**SUBDIVISION COMMITTEE
METROPOLITAN AREA PLANNING COMMISSION**

STAFF REPORT
(Preliminary Plat)

CASE NUMBER: S/D 93-76 QUAIL CREEK ESTATES

STAFF REPORT

VICINITY MAP:

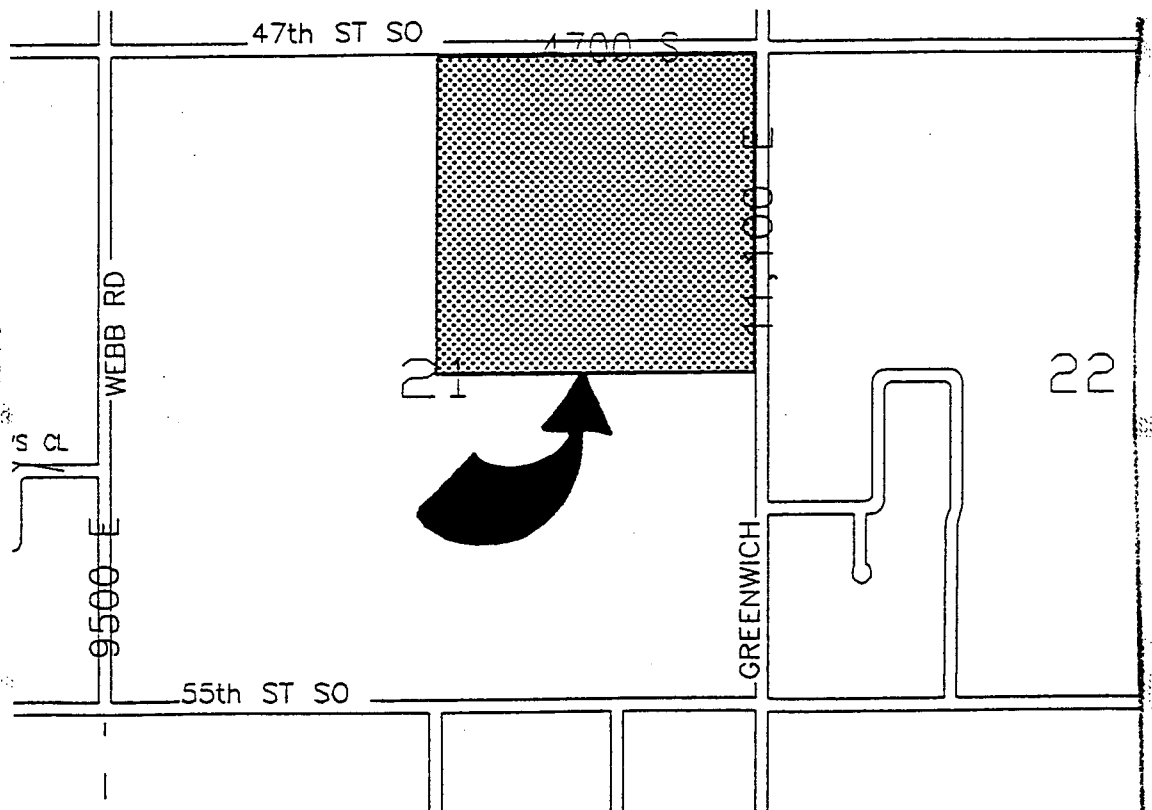
- A. While this site is in part being reconfigured to accommodate comments made in regard to the sketch plat for this site, it was not intended that the area now shown as an exception be excluded. Provided that this piece of property is in the ownership of the applicant(s), it should be platted at this time and the final plat shall indicate this area at least as one lot. Lot numbers and block letters should be adjusted accordingly.

- F. Except for Lots 4 and 5, Block A, adjacent to Greenwich Road and Lot 12, Block A adjacent to 47th Street South, all lots abutting these streets shall indicate and dedicate complete access control to these arterial streets. For the three (3) lots which only have access by means of these streets, access control except one opening per lot shall be dedicated.

- G. Based upon the Comprehensive Plan, a recreational corridor is intended across the northwest corner of this plat. The applicant is indicating a corridor for such a purpose. If the applicant wishes to establish this corridor through the plat, the plattor's text on the final plat needs to clearly indicate the granting of this access area to the public and any relevant conditions for the use, maintenance, etc. of the access area (corridor).

- H. On the final plat, Saddle Road shall be indicated as a Circle, i.e., Saddle Road Circle. However, since the stub street at the south line of this plat is not ending in a cul-de-sac (at this time) and aligns with this plat's use of Saddle Road, this stub section of street should be labeled as Saddle Road.

- I. Approval of this plat will require a waiver of the lot depth to width ratio of the Subdivision Regulations. The Subdivision Regulations state that, "the maximum depth of all residential lots shall not exceed 2-1/2 times the width thereof."

VICINITY MAP:

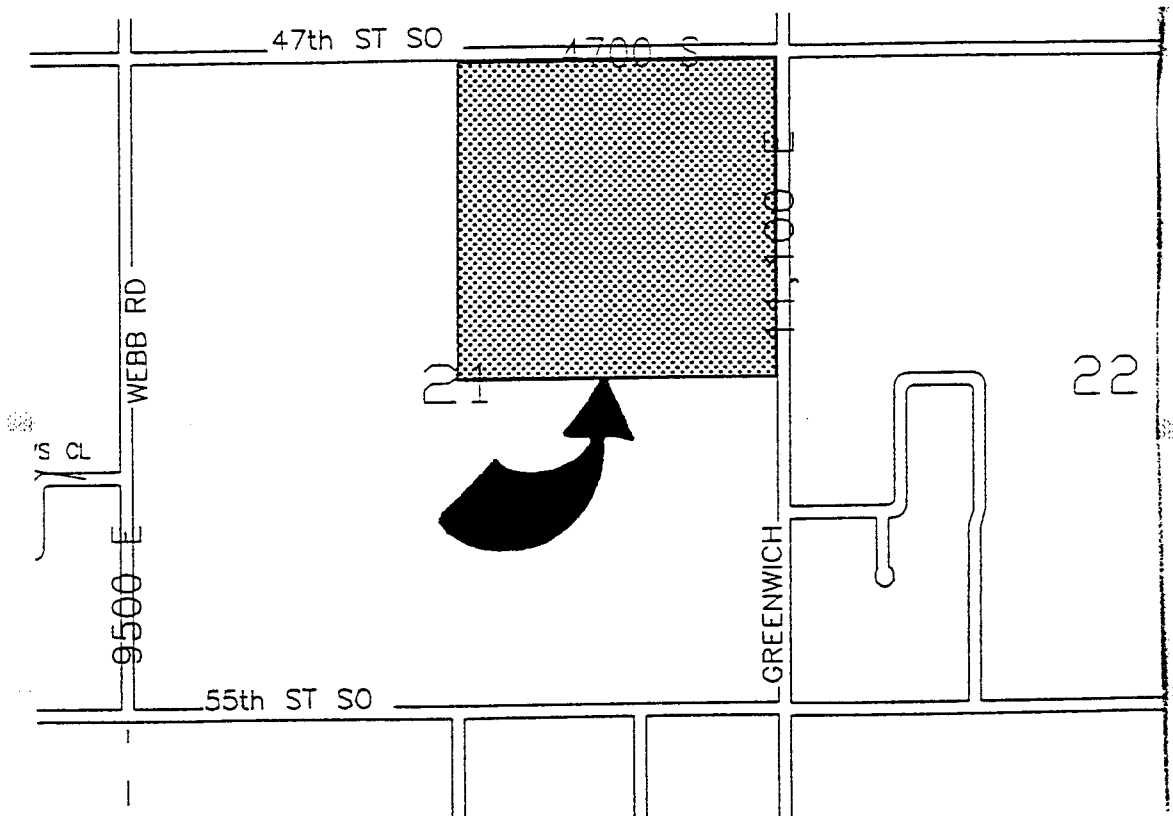
- L. On the final plat, since the street coming off of 47th Street South ends in a cul-de-sac, the street shall be named Saddle Road Circle. For the street segment at the south line of this plat, the street name Saddle Road shall also be used, but without the Court designation. West of this street segment, Quail Creek should be shown as a Circle. The representative from the County Fire Department needs to indicate if the use of "Road" in these street names is acceptable, that is, should these streets be simply named Quail Creek, Saddle and as necessary Circles.

- N. On the final plat, sufficient information (dimensions, bearings, etc.) shall be provided to adequately locate the various drainage easements located on the lots in this Addition.

VICINITY MAP:

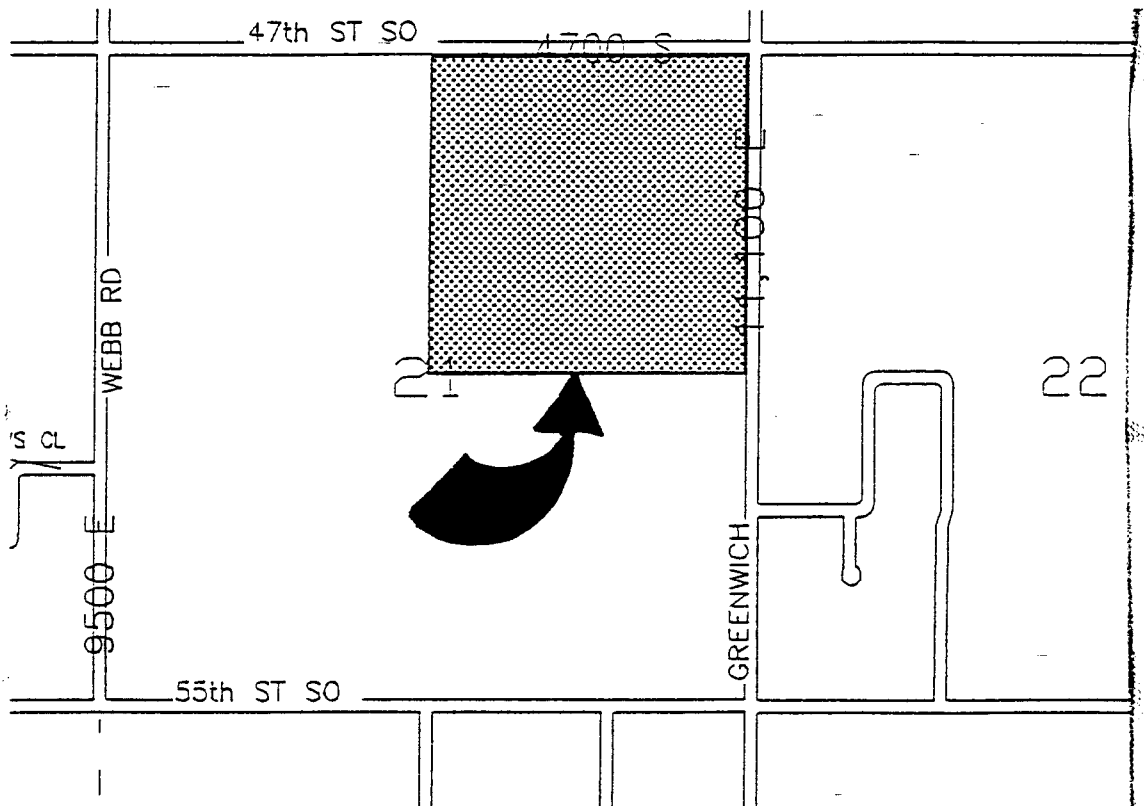
- E. On the final plat tracing, it shall be clearly indicated if the elevations are for the lowest floor or opening; County Engineering shall clarify which is the appropriate designation.

- G. On the final plat tracing, the platlor's text shall be revised to indicate that streets are being dedicated to and for the use of the public.
- H. It shall be noted that the minimum building pad elevations are in MSL (mean sea level).

- I. The final plat tracing shall as appropriate use larger print; e.g., access control to 47th Street, side lot easements, etc. Both the Register of Deeds, and microfilming of the plat require a minimum print size of 7-pts.

- J. The final plat tracing shall label as "CL", the center lines of both 47th Street and Greenwich.
- K. On the final plat tracing, Saddle Road's south line along the boundary of the plat shall be shown as a dashed line rather than a solid line.
